# **HINCKLEY NATIONAL RAIL FREIGHT INTERCHANGE**

## **Stage 1 Road Safety Audits and Response Report (Local Road Network)**

Document reference: 21.1.1

Stage 1 Road Safety Audit

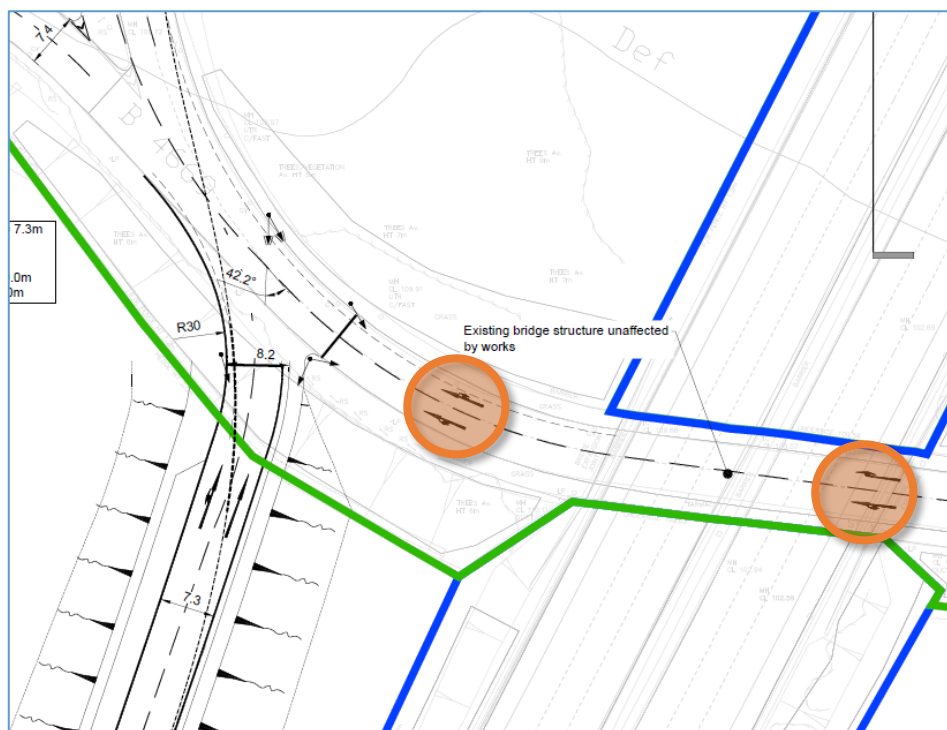
3.2. **Problem 1**

Location: M69 J2 southern circulatory carriageway.

Summary: Confusing road markings risk side swipe type collisions.

Around the southern carriageway of the circulatory the lane destinations show an “ahead” and a “right turn” arrow. However, approaching the junction and on the approaches before this point, “ahead” and “ahead and right” arrows are shown. This could lead to late lane changes, sudden and unexpected braking and side swipe type collisions due to driver confusion and late decision making as a result of confusing and misleading lane destinations.

It is recommended that the markings are amended so that they are consistent with the available movements around the southern half of the circulatory and on the westbound link road exit.

RSA Ref.	RSA Problem and Recommendation	Design organisation response	Overseeing organisation response	Agreed RSA action
3.2	<p>Location: M69 J2 southern circulatory carriageway.</p> <p>Summary: Confusing road markings risk side swipe type collisions.</p> <p>Around the southern carriageway of the circulatory the lane destinations show an “ahead” and a “right turn” arrow. However, approaching the junction and on the approaches before this point, “ahead” and “ahead and right” arrows are shown. This could lead to late lane changes, sudden and unexpected braking and side swipe type collisions due to driver confusion and late decision making as a result of confusing and misleading lane destinations.</p> <p>Recommendation:</p> <p>It is recommended that the markings are amended so that they are consistent with the available movements around the southern half of the circulatory and on the westbound link road exit.</p>	<p>Agree with RSA Recommendation: Yes</p> <p>Road markings on the circulatory will be reviewed during detailed design to ensure consistency.</p>

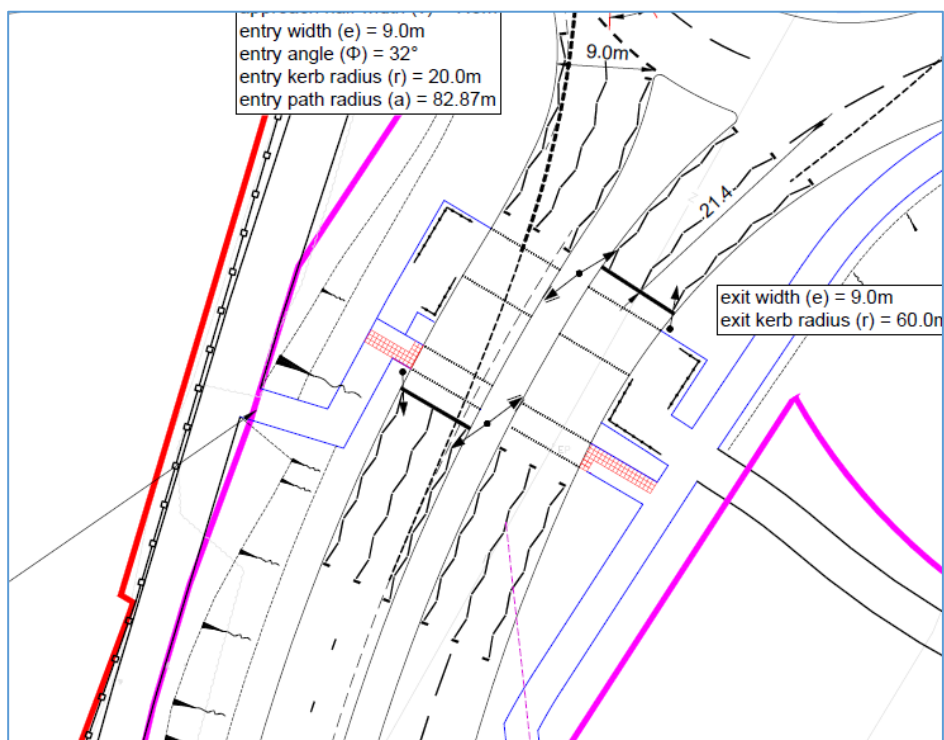
### 4.1. Additional Observation 1

Between J2 on the M69 and the first internal roundabout it is proposed to install a Pegasus crossing. The crossing is shown as a single stage crossing for all users, with the roundabout to the north shown as only a two-arm junction at this time. The crossing is approximately 18m in length - as part of the detailed design it should be ensured that the crossing timings and on-crossing detection account for slow moving equestrians, especially as the central splitter island is not of sufficient width for equestrian or cyclists to safely wait.

4.1	<p>Between J2 on the M69 and the first internal roundabout it is proposed to install a Pegasus crossing. The crossing is shown as a single stage crossing for all users, with the roundabout to the north shown as only a two-arm junction at this time. The crossing is approximately 18m in length - as part of the detailed design it should be ensured that the crossing timings and on-crossing detection account for slow moving equestrians, especially as the central splitter island is not of sufficient width for equestrian or cyclists to safely wait..</p>	<p>Noted. Crossing timings will be specified at detailed design with due regard for all potential users of the crossing.</p>

Figure 2 – Problem Location Plan

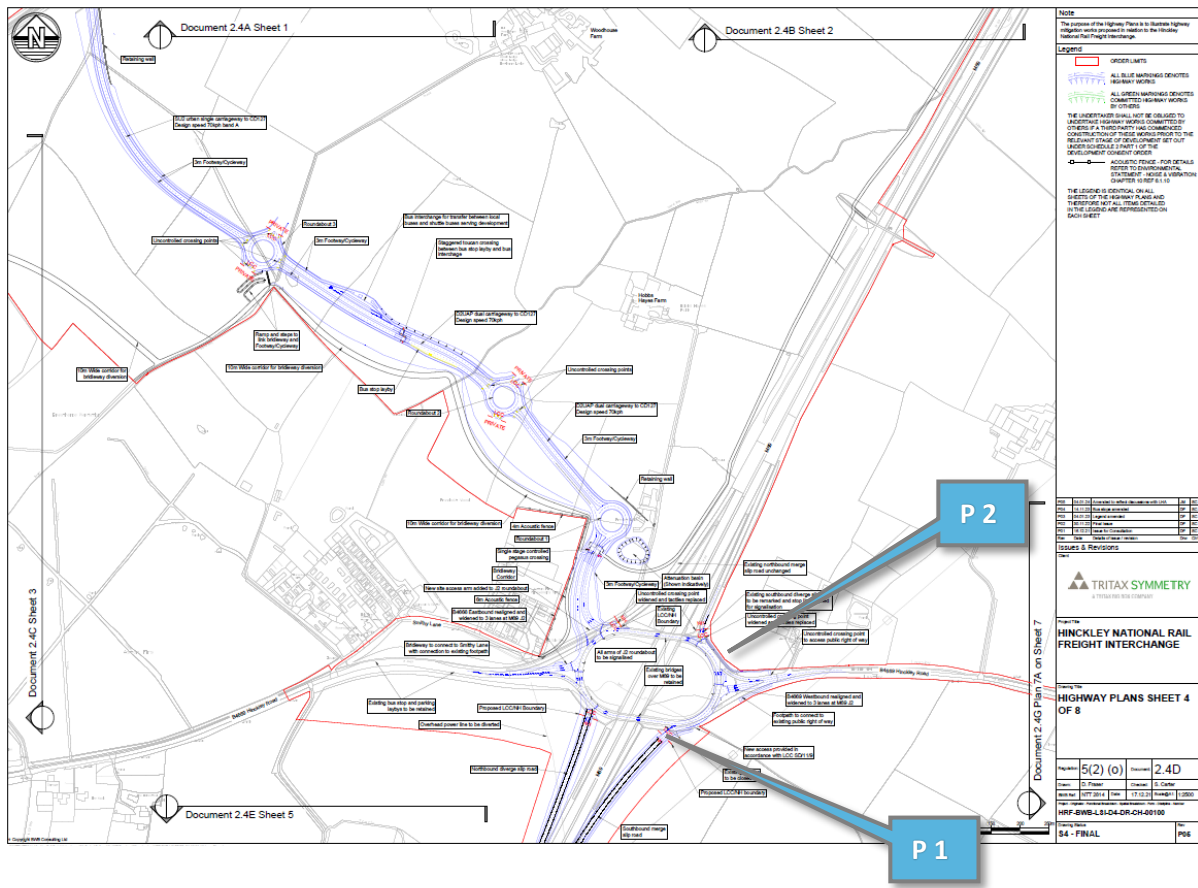
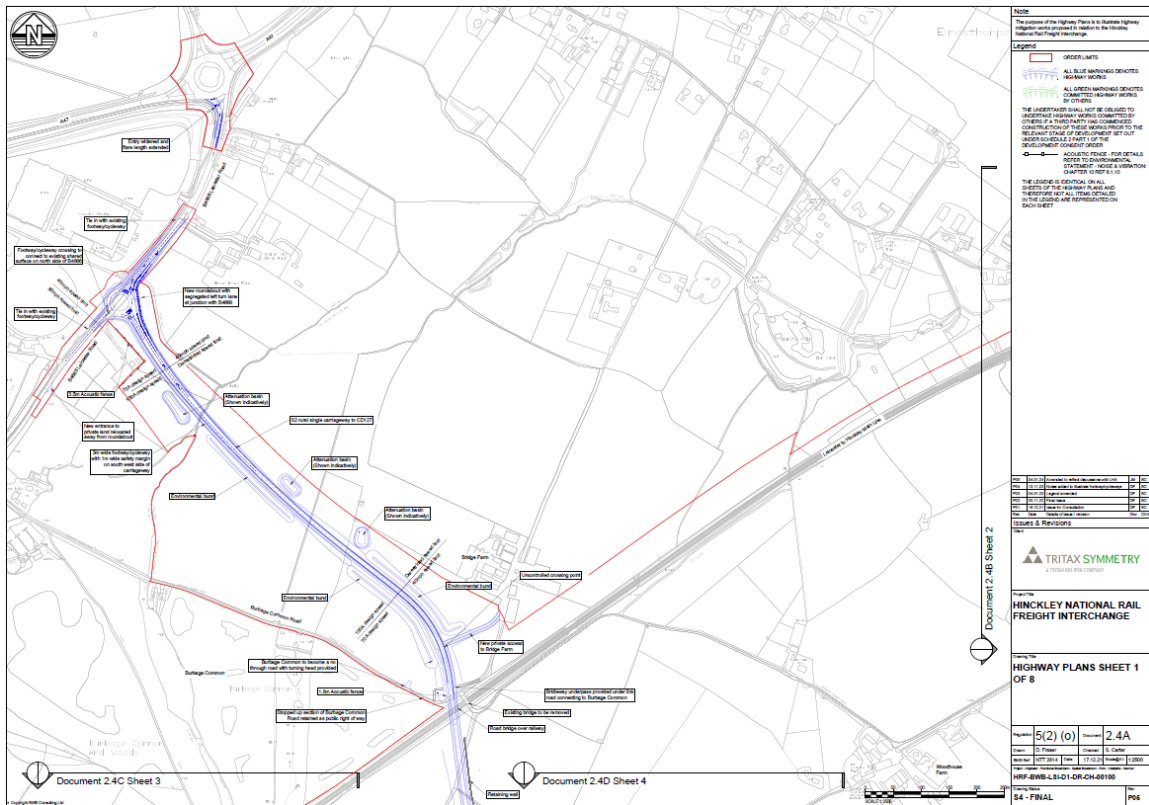
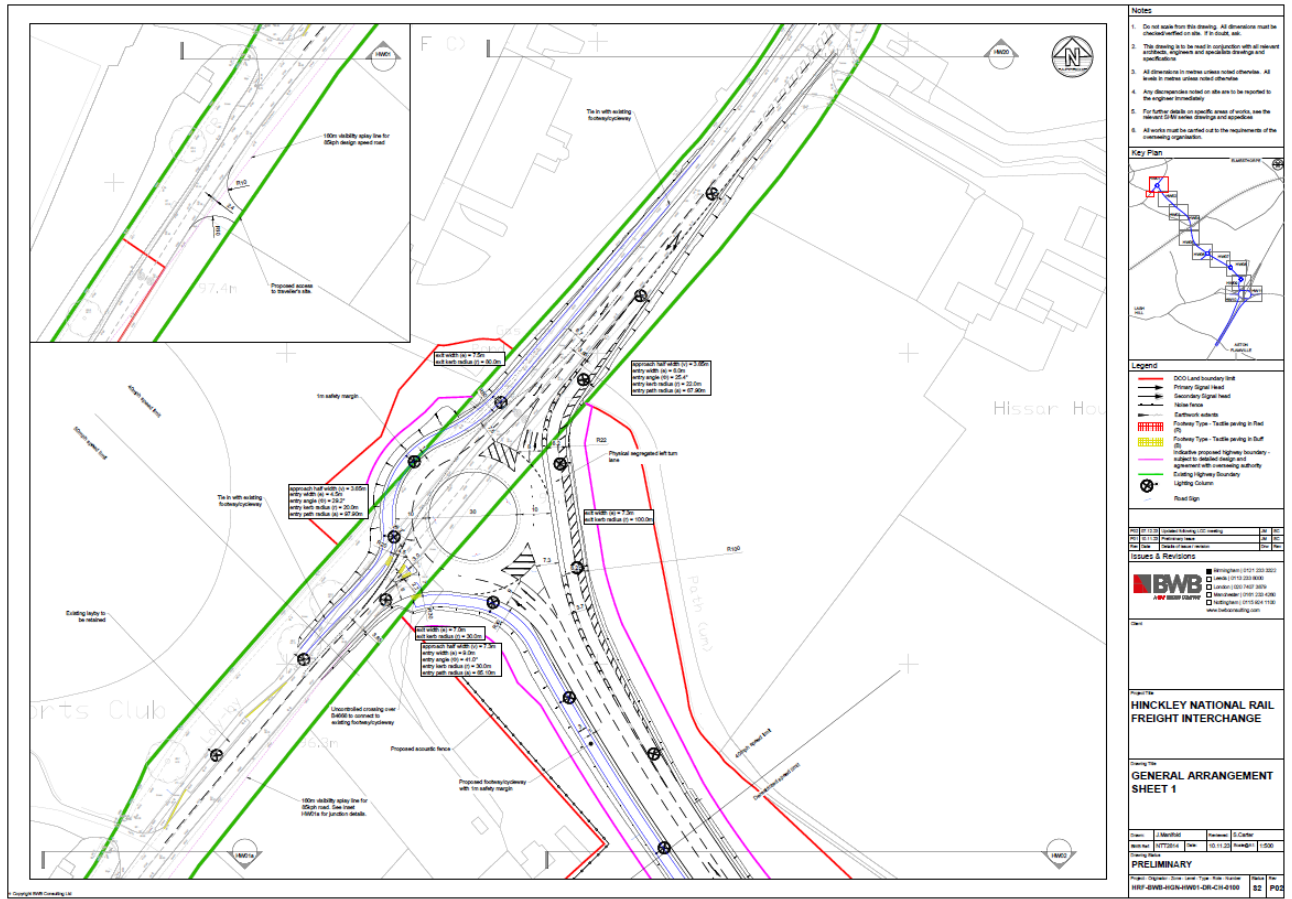
3.3. **Problem 2**

Location: M69 southbound approach to the new signalised junction.

Summary: Poor forward visibility of signals risks late braking and junction overshoot type collisions.

The southbound off-slip approach to the proposed signals at Junction 2 has a significant vertical and horizontal alignment change on the approach to the current Give-Way line. There is a concern that, given these changes and the existing signing infrastructure, that forward visibility towards the signal heads will not be provided for vehicles.

It is recommended that the signals are located and designed, including raised poles and/or gantry signals if needed, so as to provide adequate forward visibility for approaching vehicles. Furthermore, it is recommended that the signing on the approach is amended so as not to pose an obstruction.

RSA Ref.	RSA Problem and Recommendation	Design organisation response	Overseeing organisation response	Agreed RSA action
3.3	<p>Location: M69 southbound approach to the new signalised junction.</p> <p>Summary: Poor forward visibility of signals risks late braking and junction overshoot type collisions.</p> <p>The southbound off-slip approach to the proposed signals at Junction 2 has a significant vertical and horizontal alignment change on the approach to the current Give-Way line. There is a concern that, given these changes and the existing signing infrastructure, that forward visibility towards the signal heads will not be provided for vehicles.</p> <p>Recommendation:</p> <p>It is recommended that the signals are located and designed, including raised poles and/or gantry signals if needed, so as to provide adequate forward visibility for approaching vehicles. Furthermore, it is recommended that the signing on the approach is amended so as not to pose an obstruction.</p>	<p>Agree with RSA recommendation: Yes</p> <p>Visibility on the existing southbound diverge slip road has been assessed and full stopping sight distance compliant with CD 122 and the design speed of the slip road (70kph) will be made available through the detailed design incorporating site clearance works and relocation of existing signage to ensure that there are no significant obstacles within the visibility envelope.</p>

Figure 2 – Problem Location Plan

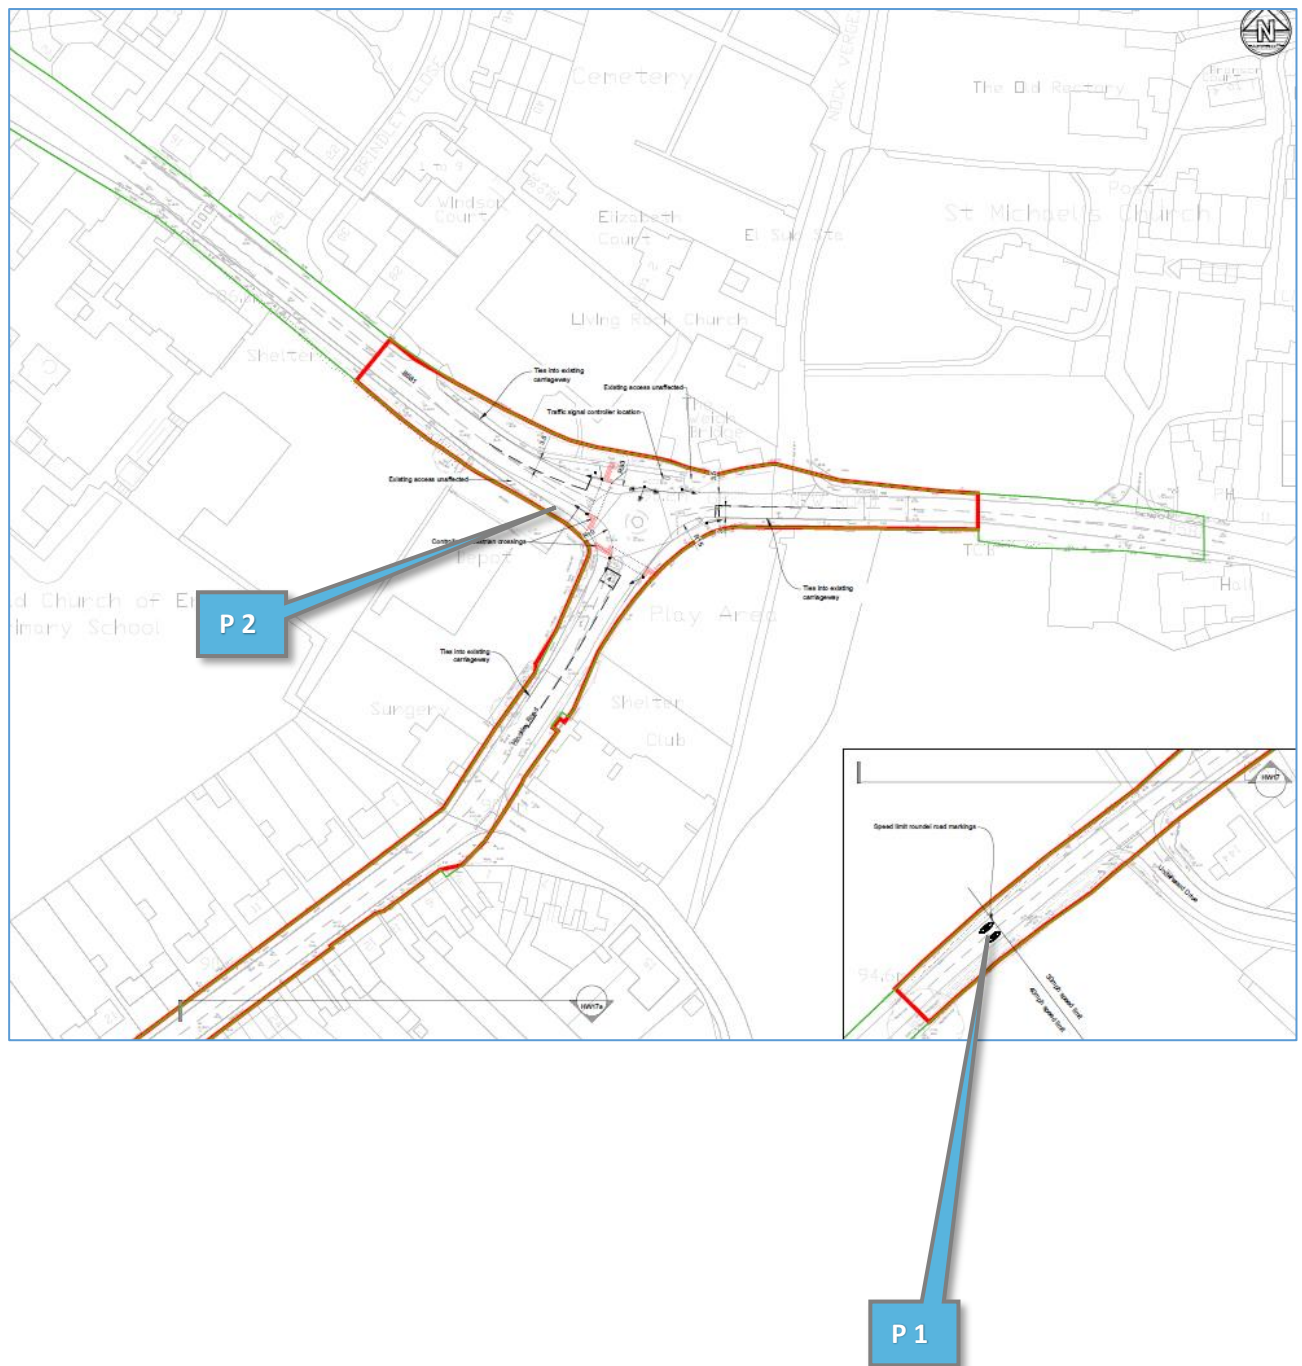
It is proposed to reduce the speed limit on Stanton Lane and Hinckley Road to 40mph from the existing national speed limit (60mph for most vehicles). This represents a significant reduction with no obvious changes to the surrounding environment that would indicate why a 40mph speed would be viewed as ‘appropriate’ by drivers. As such, there is a risk of significant disparities between vehicle speeds should some drivers continue at higher speeds whilst others comply to the proposed lower limit, resulting in shunts and overtaking collisions.

It is recommended that a speed survey is undertaken to determine likely compliance with the lower limit. Should speeds be significantly higher than the proposed limit and compliance therefore unrealistic, given a sign only reduction is likely to result in a small reduction in measured speeds, it is recommended that additional measures to support the lower limit are provided, or that the proposed limit is amended in accordance with the results returned from the speed survey.

RSA Ref.	RSA Problem and Recommendation	Design organisation response	Overseeing organisation response	Agreed RSA action
3.2	<p>Location: Stanton Lane / Hinckley Road – general.</p> <p>Summary: Significant discrepancies in vehicle speeds may lead to shunts and overtaking collisions.</p> <p>It is proposed to reduce the speed limit on Stanton Lane and Hinckley Road to 40mph from the existing national speed limit (60mph for most vehicles). This represents a significant reduction with no obvious changes to the surrounding environment that would indicate why a 40mph speed would be viewed as 'appropriate' by drivers. As such, there is a risk of significant disparities between vehicle speeds should some drivers continue at higher speeds whilst others comply to the proposed lower limit, resulting in shunts and overtaking collisions.</p> <p>Recommendation:          It is recommended that a speed survey is undertaken to determine likely compliance with the lower limit. Should speeds be significantly higher than the proposed limit and compliance therefore unrealistic, given a sign only reduction is likely to result in a small reduction in measured speeds, it is recommended that additional measures to support the lower limit are provided, or that the proposed limit is amended in accordance with the results returned from the speed survey.</p>	<p>Agree with RSA Recommendation: In Part</p> <p>The designer has assessed the Stanton Lane link design speed against the requirements of CD109 Figure 2.1. The changes in direction, harmonic mean visibility, and other characteristics (such as the frequency of accesses along this section of Stanton Lane) of this link indicate a design speed of 70A which is equivalent to a speed limit of 40mph. The designer is therefore of the view that the reduction in speed limit is appropriate and will be observed by road users.</p> <p>This said, the designer will liaise with the overseeing organisation during the detailed design and if agreed to be necessary, will look to undertake further speed surveys on this link to support the case for a reduced speed limit here or to agree any further measures that might be implemented to aid road user compliance.</p>

3.3	<p>Location: B581 – western arm of the junction. Summary: Poor alignment at the traffic signals risks right turn / junction collisions.</p> <p>It is noted the at egress for the parking area on the former depot site, which it is understood is currently used by the adjacent church, is to utilise the existing eastern most access point across the site frontage. This in turn results in poor alignment towards the eastbound signal head/stop line with drivers reliant on the secondary head and a degree of driver compliance. There is a concern that this may lead to drivers entering the junction when unsafe to do so or in queuing vehicles blocking the westbound lane, risking collisions with right turning vehicles entering the B581 from Hinckley Road.</p> <p>Recommendation: It is recommended that the pedestrian and vehicular access to the car park are swapped so as to allow vehicles to align themselves appropriately at the stop line.</p>	<p>Agree with RSA recommendation: In Part The designer is of the view that the proposed arrangement is safer than the current arrangement which requires drivers to give way from two directions on a priority junction rather than to leave the access under signal control. The risk of queueing or blocking the junction currently exists and is more likely given that there is no signal control here at present.</p> <p>It should also be noted that the main egress from the church car park is onto Hinckley Road and not via the gate in question as can be seen from the images below (see road markings which direct vehicles towards the Hinckley Road access).</p>

Figure 2 – Problem Location Plan

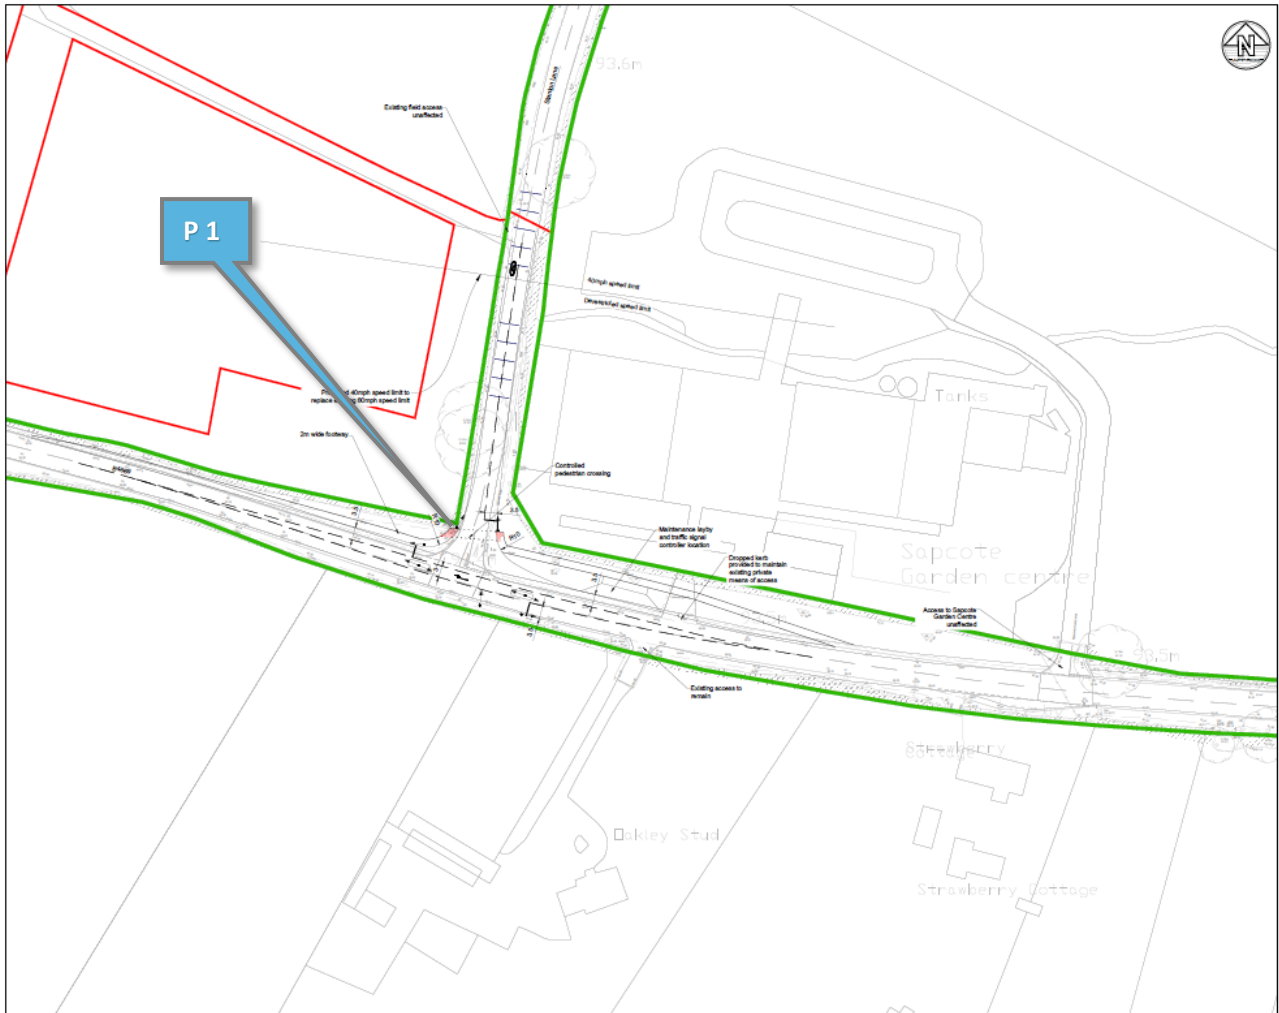
It is proposed that Stanton Lane, to north of the junction, is to have the speed limit reduced from the national speed limit to 40mph. This is the subject of comment within the accompanying report reference 24-1363.02 – it is recommended that that report be read in conjunction with this report, specifically with regard to concerns over likely adherence to the proposed lower 40mph limit.

RSA Ref.	RSA Problem and Recommendation	Design organisation response	Overseeing organisation response	Agreed RSA action
	<p>Location: Proposed controlled pedestrian crossing – Stanton Lane.</p> <p>Summary: Poor visibility for pedestrians crossing west to east risks vehicle to pedestrian collisions.</p> <p>Visibility to the north for pedestrians looking to cross west to east is restricted by the hedgerow to the north of the crossing. This is exacerbated by the crossing being located on the radius, with waiting pedestrians likely to be “tucked” around the corner adjacent to the likely controller unit location. This risks pedestrians entering the carriageway into the path of southbound vehicles, resulting in vehicle to pedestrian collisions.</p> <p>Recommendation: It is recommended that suitable, unobstructed visibility splays are provided at the crossing.</p>	<p>Agree with RSA Recommendation: Yes</p> <p><b>Visibility</b> requirements for a controlled crossing such as this are that the crossing is within the junction intervisibility splay and that vehicles approaching the junction have desirable minimum visibility to a primary signal head and desirable minimum visibility to the give way/stop line and on approach. This is because pedestrians waiting to cross do so based on the red/green pedestrian signals and not giving way to vehicle approaching from the north in this case.</p> <p>It will be demonstrated at detailed design that unobstructed visibility splays in accordance with CD 109 and CD 123 are provided to the pedestrian crossing proposed here.</p>

RSA Ref.	RSA Problem and Recommendation	Design organisation response	Overseeing organisation response	Agreed RSA action
	<p>It is proposed that Stanton Lane, to north of the junction, is to have the speed limit reduced from the national speed limit to 40mph. This is the subject of comment within the accompanying report reference 24-1363.02 – it is recommended that the report be read in conjunction with this report specifically with regard to concerns over likely adherence to the proposed lower 40mph limit</p>	<p>Noted. Please see response to the relevant problem associated with report 24-1363.04</p>
